PROGRESS MEETING MINUTES

**Basin 4100 and DFA 0056 OSP
Monday, January 29, 2018
11:00 am at Urban Drainage and Flood Control District**

The meeting was held to discuss the draft hydrology analysis and report and direction for beginning the alternatives analysis. While this summary is not intended to represent a comprehensive account of the meeting, it is intended to represent a comprehensive account of the meeting, it is intended to reflect the key points raised and issues for further consideration and to identify the action items resulting from the discussions.

**BASIN 4100 AND DFA 0056
 HYDROLOGY WORKMAP**

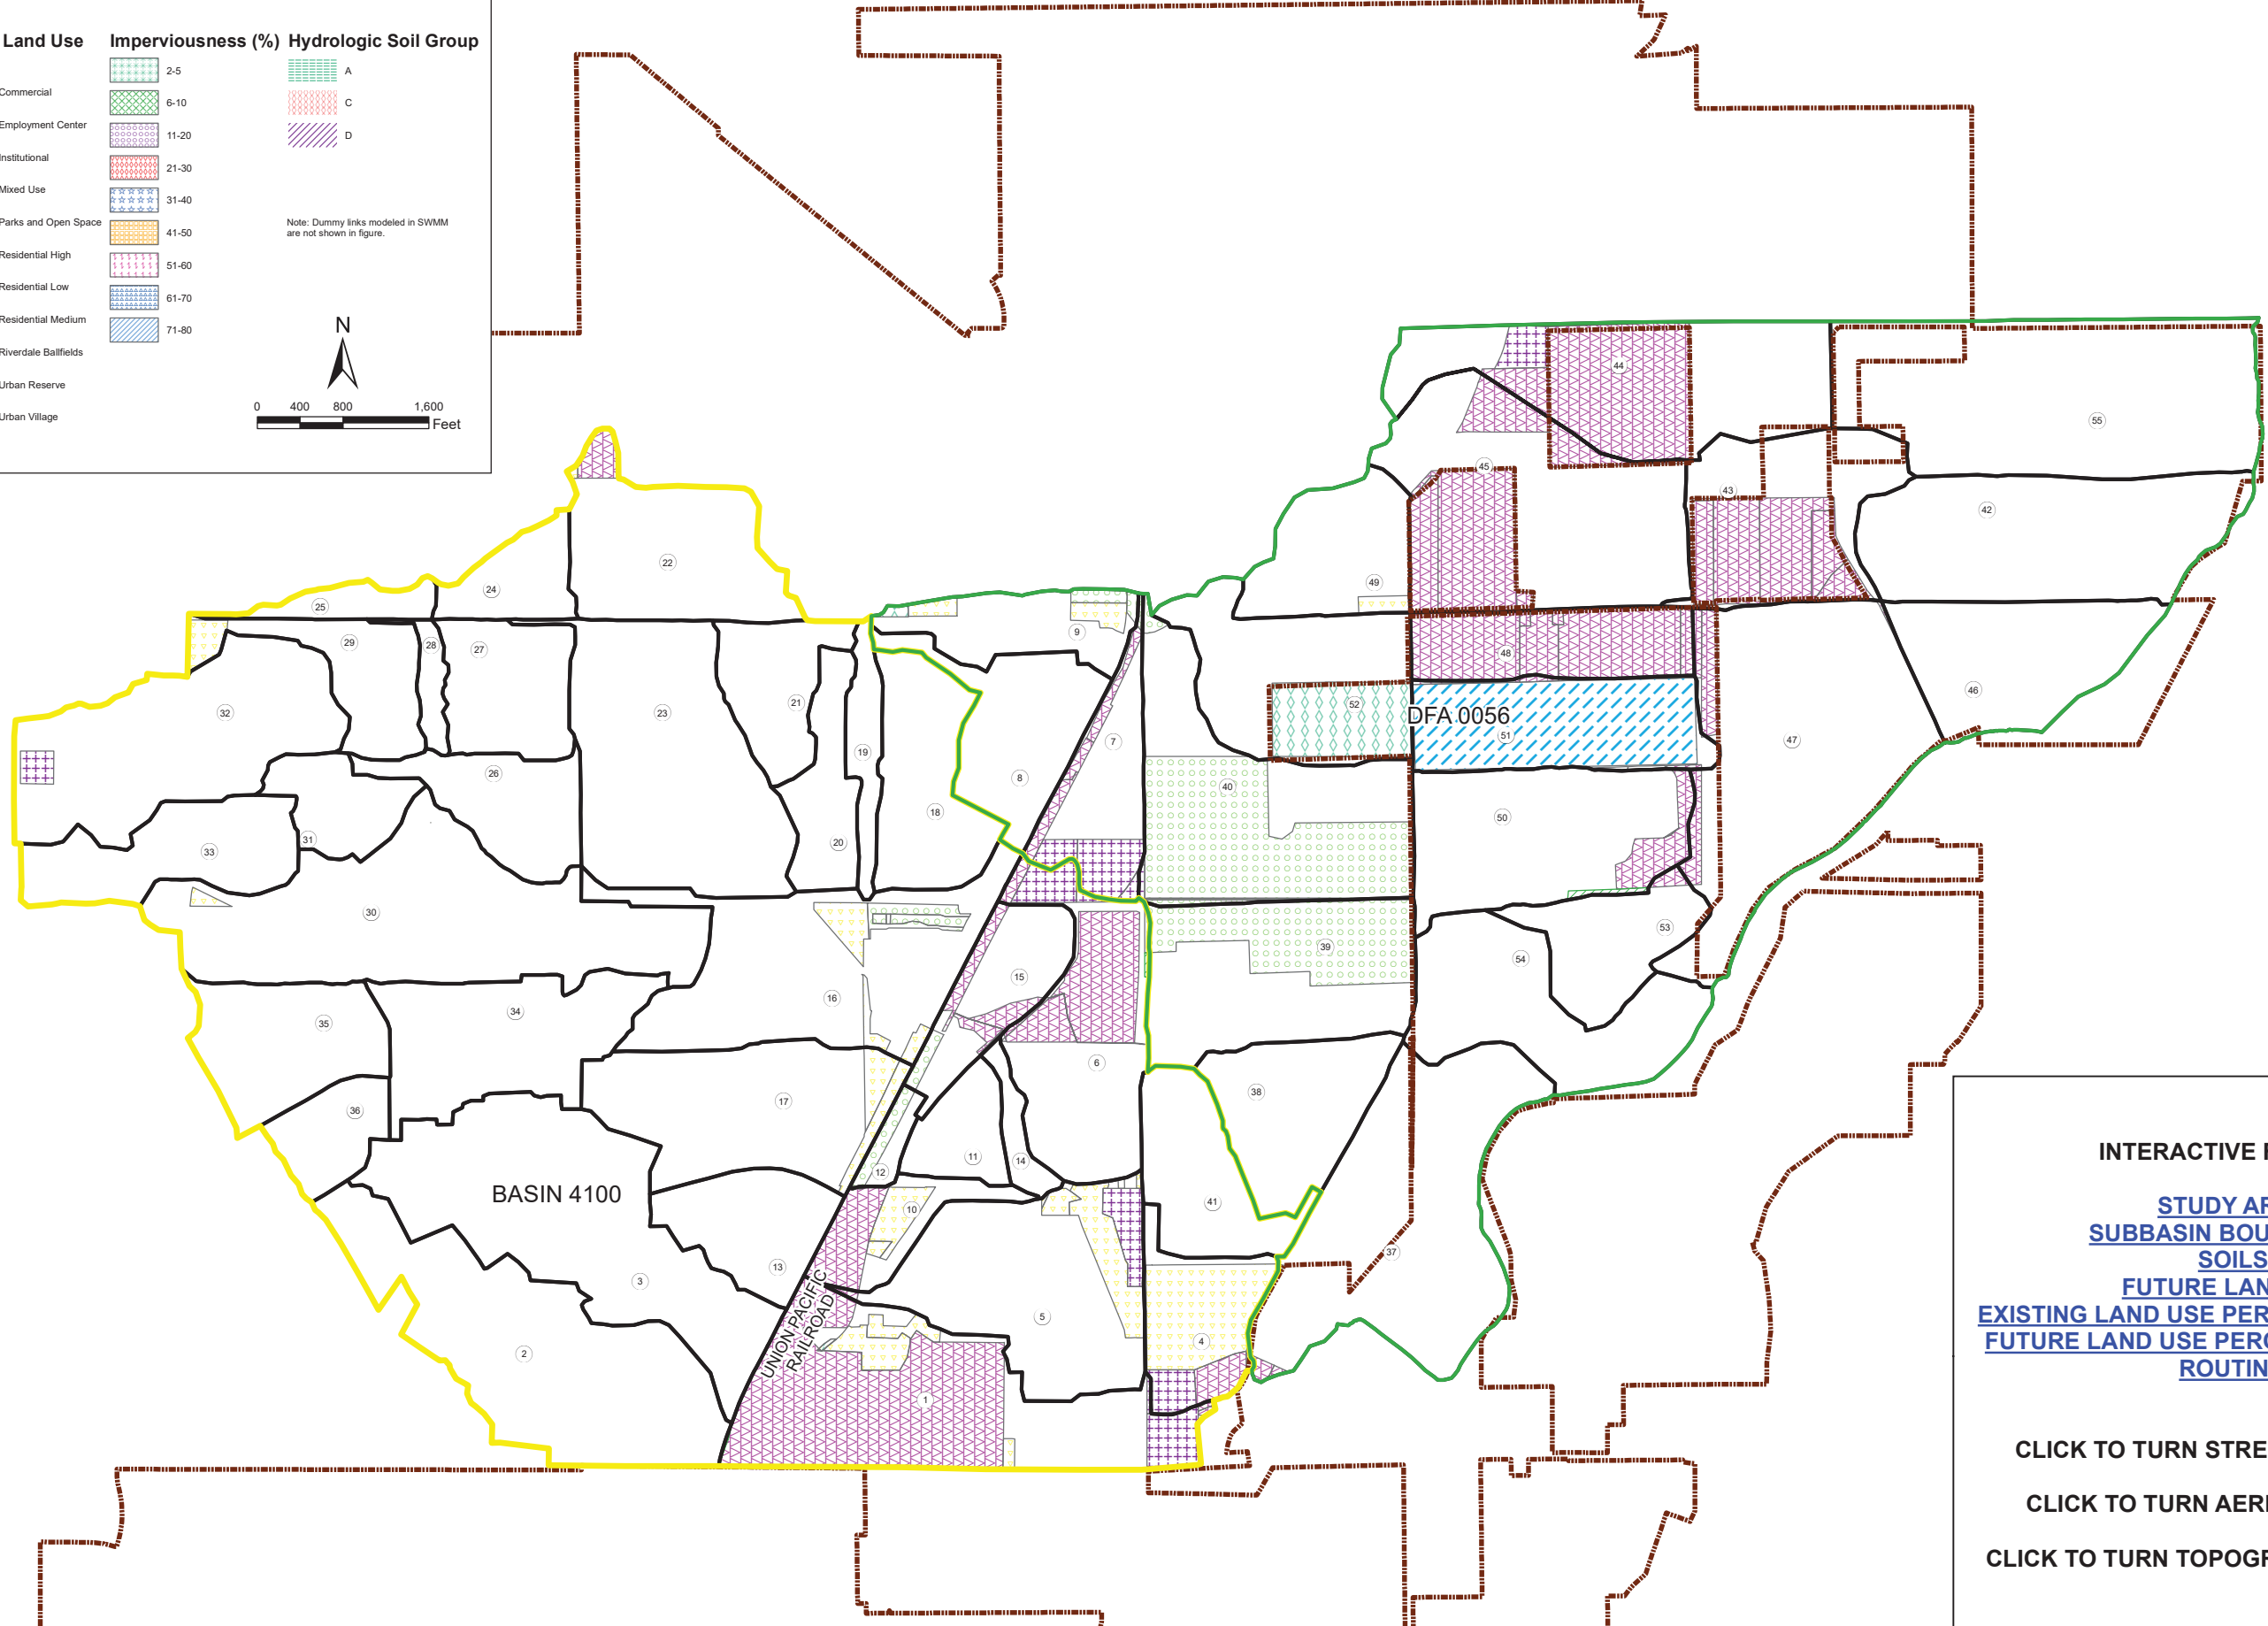
- iii) Future road to change flow path – include in baseline hydrology?
 - (1) Road construction has not occurred yet, but West Spratt Platte Lake has already had work done to fill in the southern finger of the lake. The boundary between 53 and 47 will be altered to represent this construction and the future changes.

- v) Sub-basin 53 drainage
 - (1) Boundary between sub-basins 53 and 47 will be re-delineated to reflect changes to the West Spratt Platte Lake where the finger was filled in.

- j) SWMM Routing
 - i) Figure B-2C – future change?
 - (1) Boundary between sub-basins 53 and 47 will be re-delineated as previously described.
- 2) Problem areas and alternatives analysis

FIGURE 3

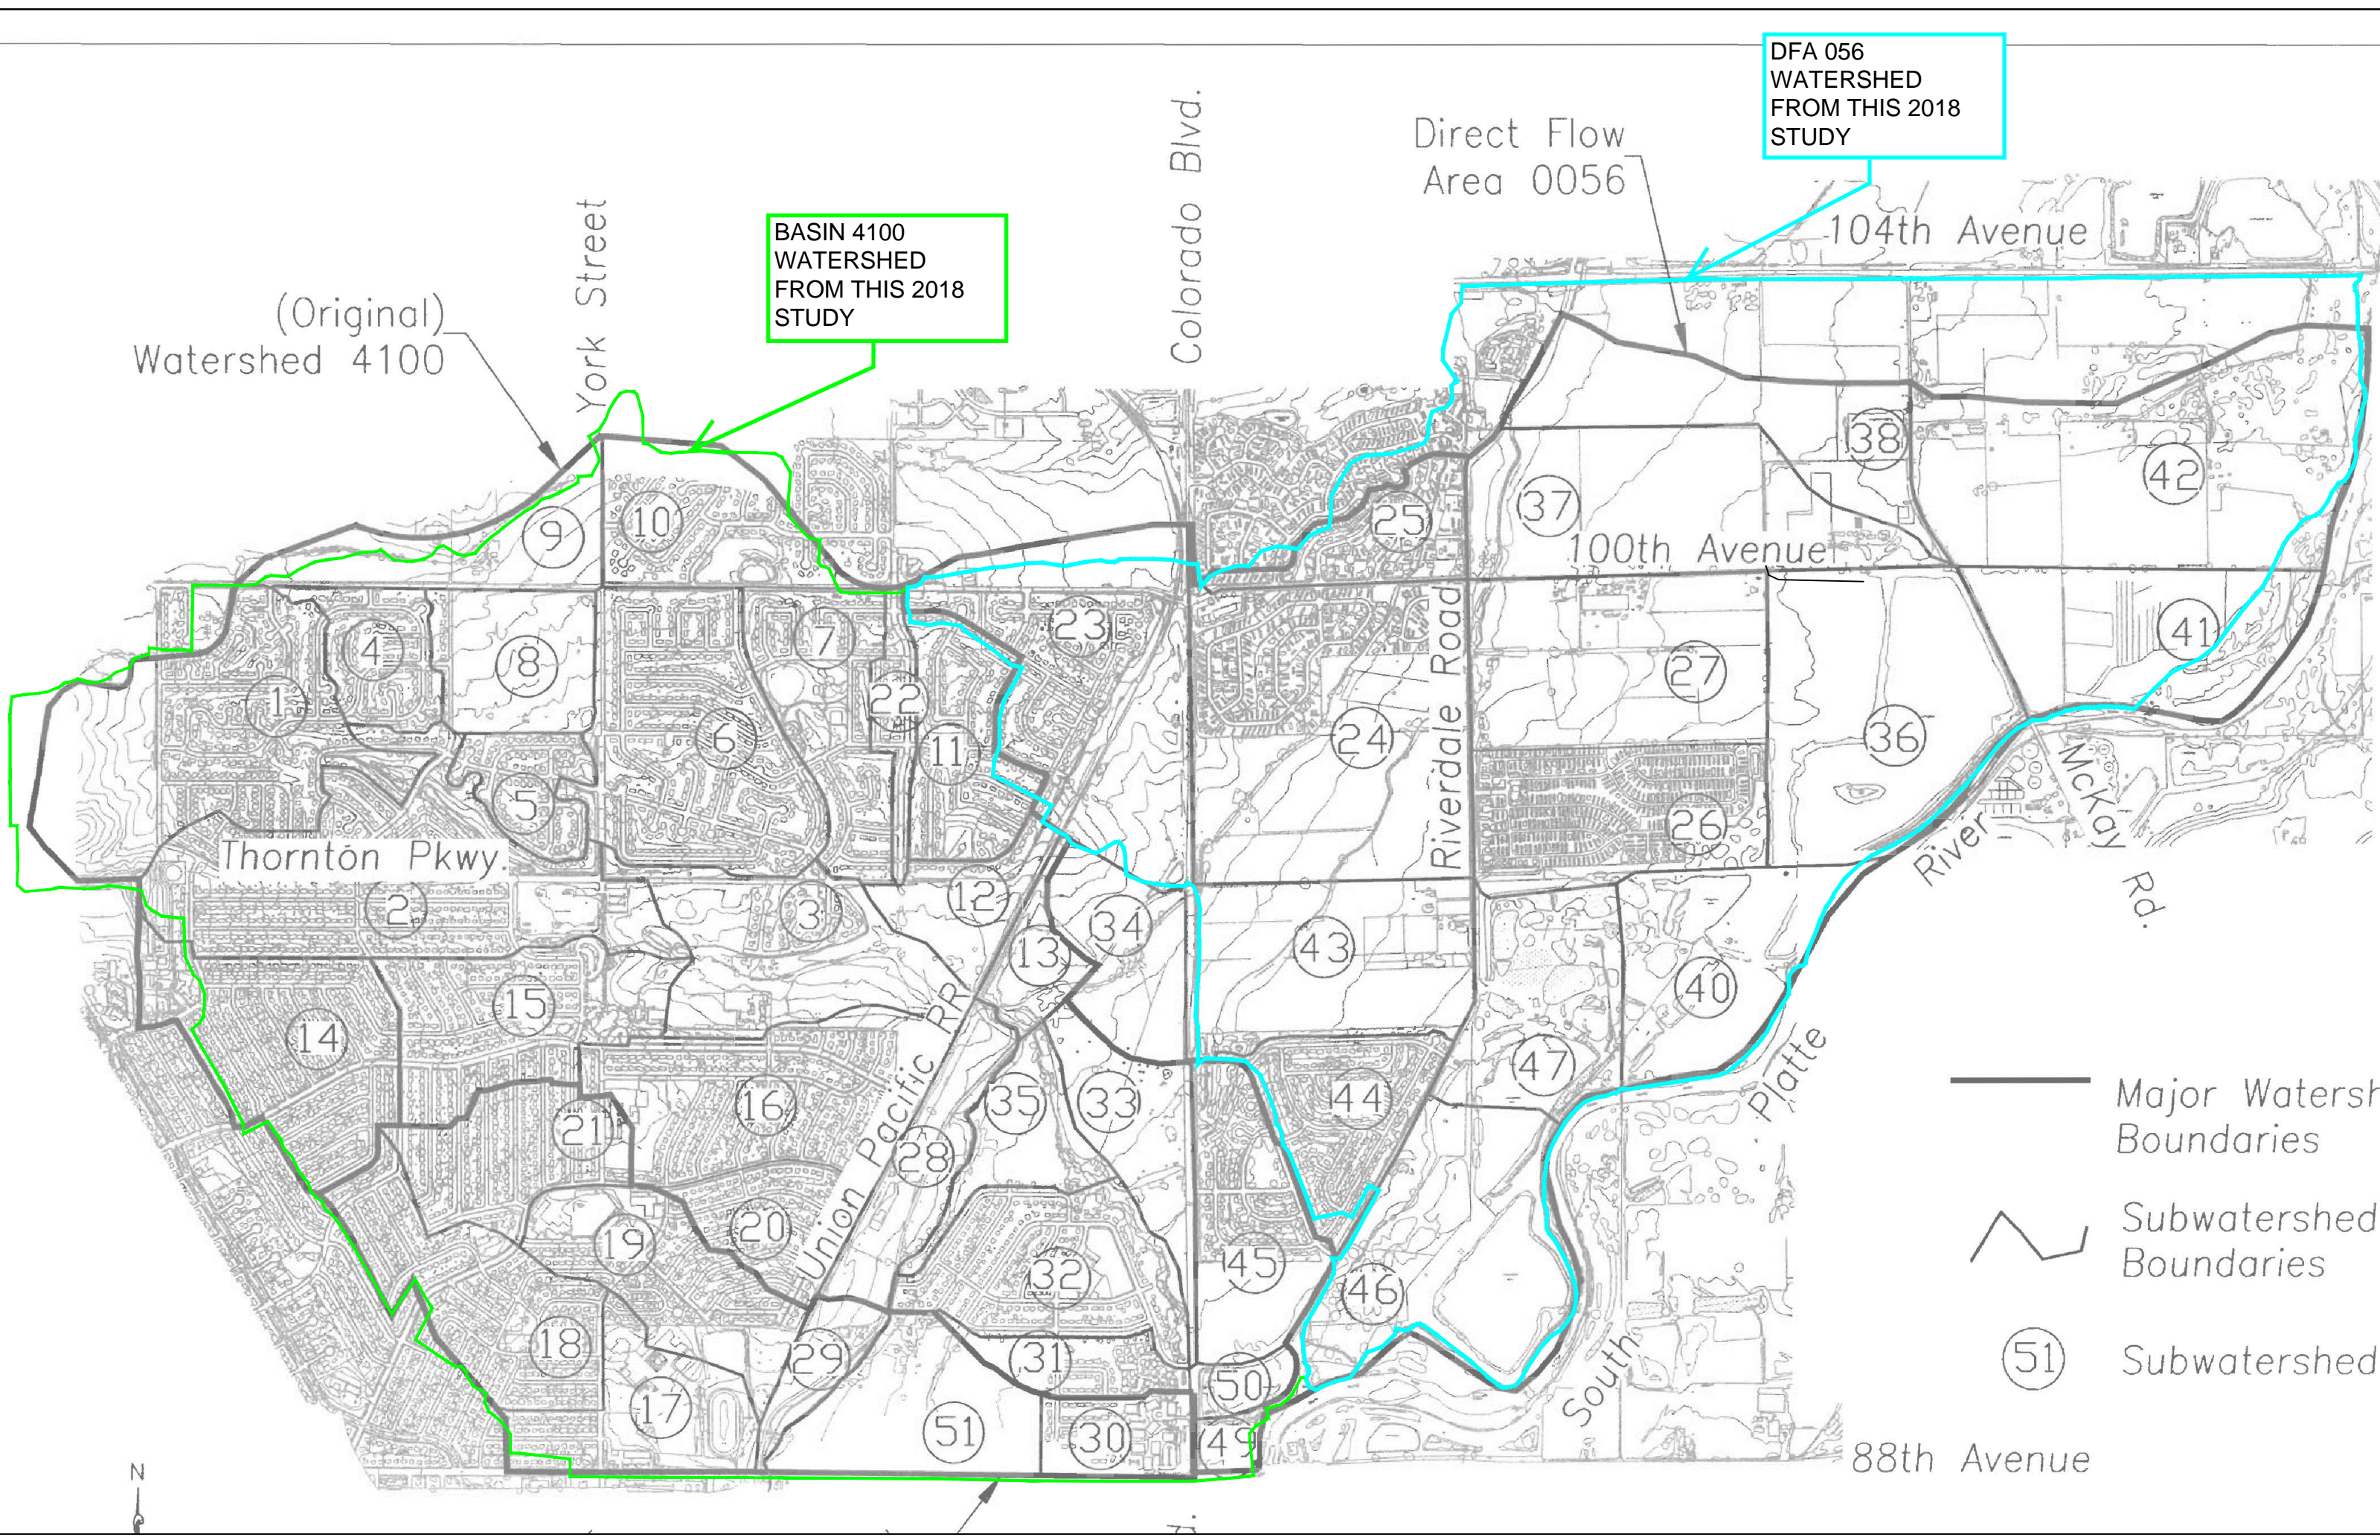
- (3) Olsson will provide separate comparisons for Basin 4100 and DFA 0056.
 - ii) Additional watershed acreage difference from 2002 OSP is due to delineating the basins based on LiDAR.

- (1) The largest difference is for sub-basins 44 and 55, previously numbered 38 and 42, respectively. Delineation was done using LiDAR data, and differences were due to changes that have since been made in the watershed. A figure comparing the old study watershed areas and this study was presented during the meeting is included in the meeting minutes.
